Re: Florida Power & Light Company
Proposed Turkey Point Units 6 and 7
Docket Nos. 52-040 and 52-041
Voluntary Revised Response to NRC Request for Additional Information Letter No. 041 (eRAI 6024) SRP Section: 02.05.01 - Basic Geologic and Seismic Information

Attachment: FPL Revised Response to NRC RAI No. 02.05.01-15 (eRAI 6024)

NRC RAI Letter No. PTN-RAI-LTR-041

NRC RAI Number: 02.05.01-15 (eRAI 6024)

Figure 1. (A) Time section of Santaren Anticline from Ball et al. (1985) (FSAR Reference 2.5.1-501, Figure 9). (B) Migrated depth section of profile from (A) with 2x vertical exaggeration. Ball et al. (1985) (FSAR Reference 2.5.1-501) propose a fault as dashed.

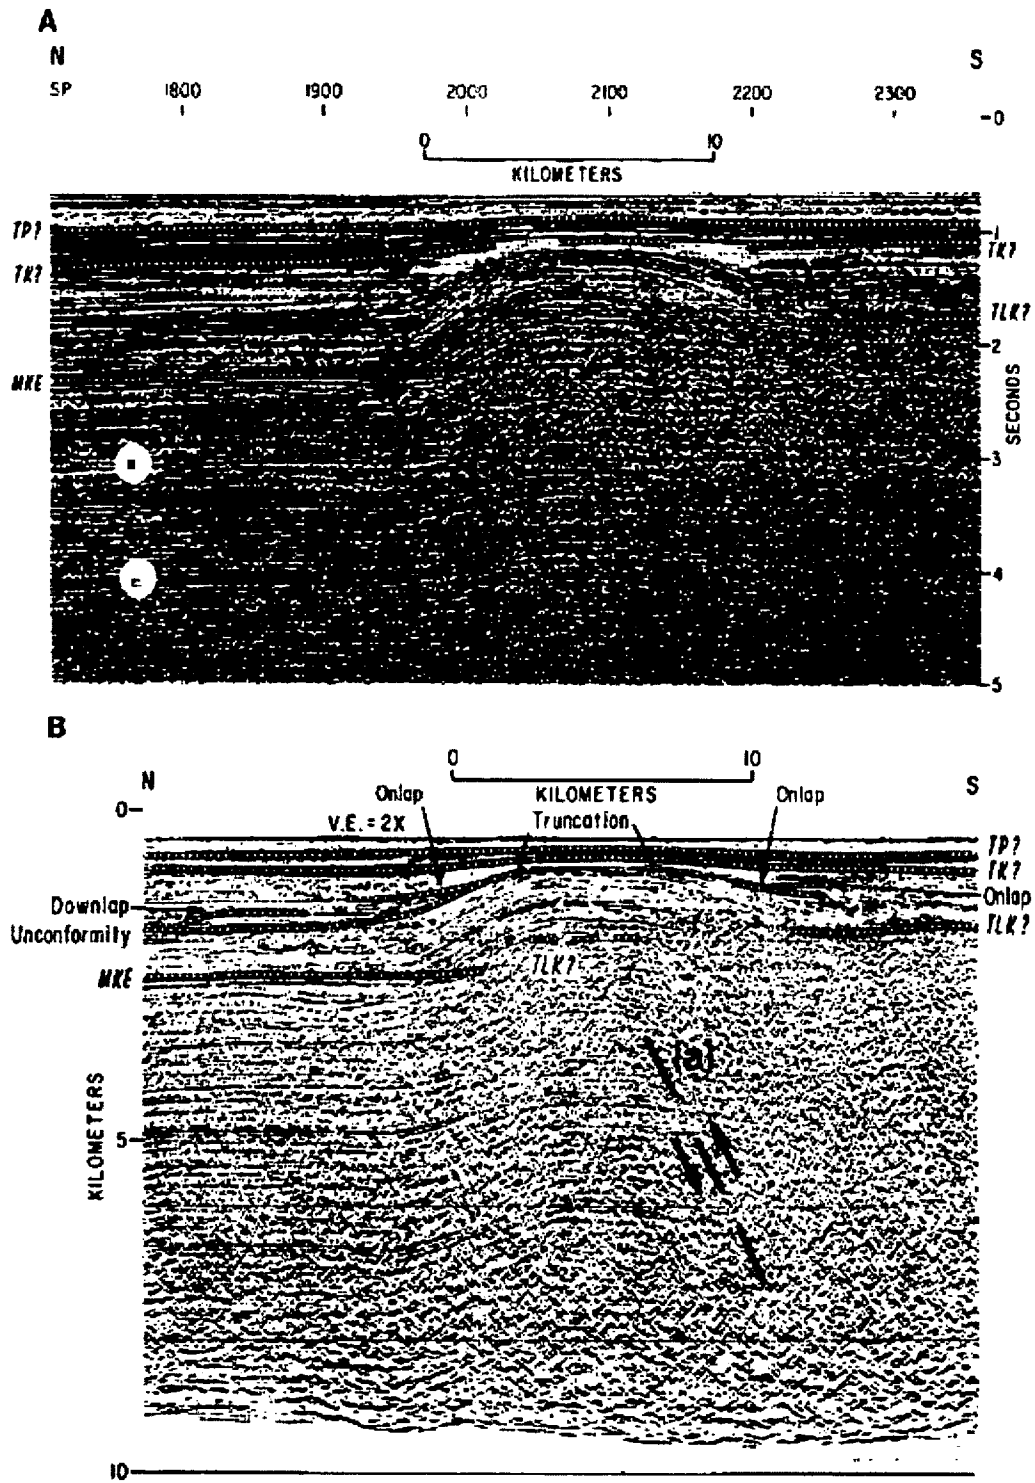
- a) In light of evidence for ongoing deformation (References 477, 479, and 501), discuss the present day rates of shortening calculated across the anticline (see also Maserferro et al, 1999).
- b) Plot regional seismicity on a close-up view of the Santaren Anticline and comment whether the Santaren Anticline is a capable tectonic structure.
- c) Provide a discussion regarding the possibility that the Santaren Anticline and the Nortecubana fault system are linked.

Ball et al. (1985) (FSAR Reference 2.5.1-501, pp. 1,290-1,292) also provide a structural interpretation of the Santaren anticline in their Figure 9b (Figure 1), noting “Deep terminations occur, below 4 km depth, in inferred basinal sediments beneath the anticline, 3 km north of the zone of dip and thickness variation. Some major dislocation related to faults may have caused the aberrant dips and local thickness variations. However, the regional thinning was caused by southward onlap of basinal carbonates on shallow-water carbonate material. Subsequent compressional tectonism produced the anticline.” Based on the previously quoted age determinations, the location of the anticline, the interpreted asymmetry of the anticline, and the interpretation of a fault below 4 km depth, Ball et al. (1985) (FSAR Reference 2.5.1-501, p. 1,294) state “We speculate that this structure is a hanging-wall anticline marking the northern limit of thrusting in the Cuban arc.”

Ball et al. (1985) (FSAR Reference 2.5.1-501) do not calculate shortening rates for the Santaren anticline. Furthermore, it should be noted that the location of the steeply dipping fault dashed in Ball et al.'s (1985) (FSAR Reference 2.5.1-501) Figure 9b (Figure 1) is kinematically incompatible with the location of the Santaren anticline. As drawn, at least half of the interpreted hanging-wall anticline is actually on the footwall of the dashed fault.

Figure 3. Seismicity in the Vicinity of the Santaren Anticline.

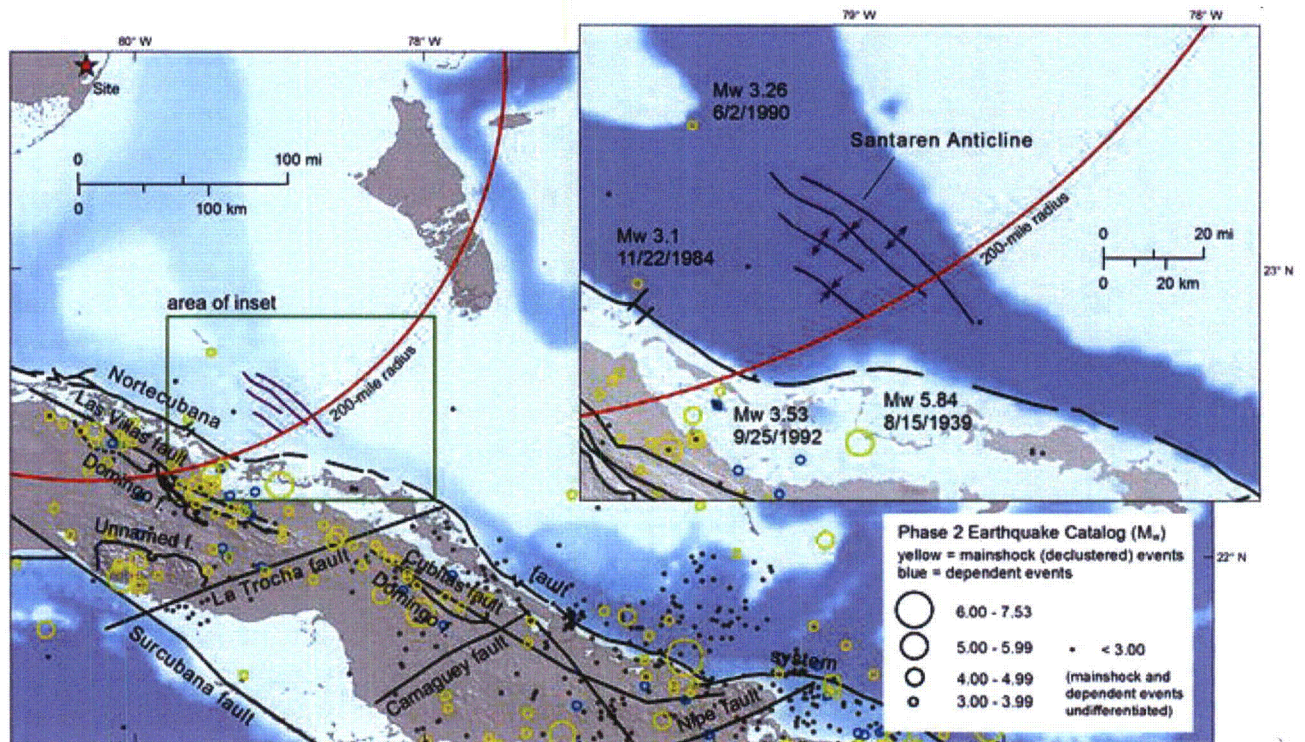
b) Plot regional seismicity on a close-up view of the Santaren Anticline and comment whether the Santaren Anticline is a capable tectonic structure.

The Santaren anticline and three unnamed fold axes directly to its southwest from Masaferrero et al. (1999) (FSAR Reference 2.5.1-426) are shown on Figure 3, along with earthquake epicenters from the Phase 2 earthquake catalog. Earthquake activity is very sparse in the vicinity of the Santaren anticline, and there does not appear to be a spatial association between seismicity and the Santaren anticline or with the unnamed fold axes directly to the southwest (Figure 3).

Regardless of these structural interpretations, the issue of whether or not the Santaren anticline is a capable tectonic structure is addressed by data presented by Masferro et al. (2002) (FSAR Reference 2.5.1-479). The calculated fold uplift rates for the Santaren anticline, as depicted in Figure 4c of FSAR Reference 2.5.1-479 (Figure 2), show no uplift since deposition of beds M2-M3. As detailed in part (a) of this response, this period of tectonic quiescence spans the period from approximately 1 Ma to present. The fact that FSAR Reference 2.5.1-479 depicts no uplift in the most recent 1 million years would therefore support the conclusion that the Santaren anticline does not represent a capable tectonic structure. The sparse seismicity near this structure further supports this argument (Figure 3).

The Associated COLA Revisions previously submitted to the NRC in Attachment 15 to FPL Letter L-2014-281, Pages 10 to 11, were incorporated in Revision 5 of the COLA. A new revision to FSAR Figure 2.5.1-350 (Figure 3 in this response) will be provided in the response to RAI 02.05.01-34 for incorporation into a future COLA revision.
